Re: **Open House June 20, 2017**
Improvements 207th Street between 118 Ave. and Dewdney Trunk Road

207 Street southbound at 119 Ave

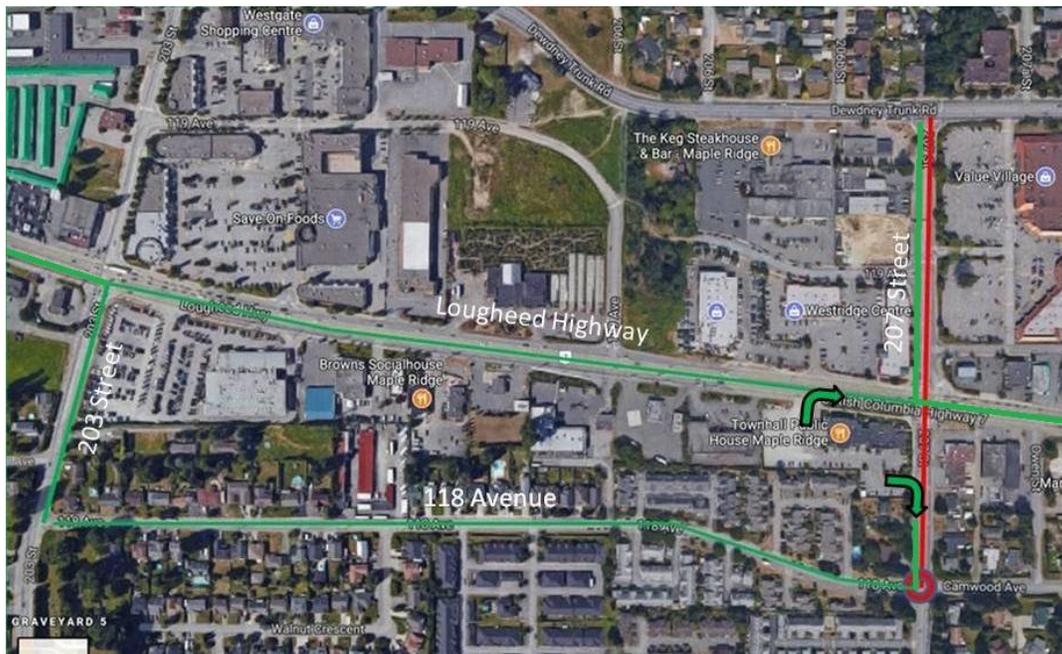
- If this segment of 207th Street is correctly classified as a minor collector road and a neighbourhood bikeway, it is being over-engineered for motor vehicles in our view. It is not clear why two through car lanes northbound and various turn lanes both north- and southbound are necessary on a road that supposedly has low traffic volumes and speeds and is supposed to safely accommodate cyclists of all ages and abilities. It gives the street an intimidating feel, and it's doubtful that most cyclists will feel comfortable sharing the road with cars.

It is our HUB committee's preference to have painted bike lanes on both sides of the road, both between Dewdney Trunk Road and Lougheed Highway as well as south of Lougheed Highway.
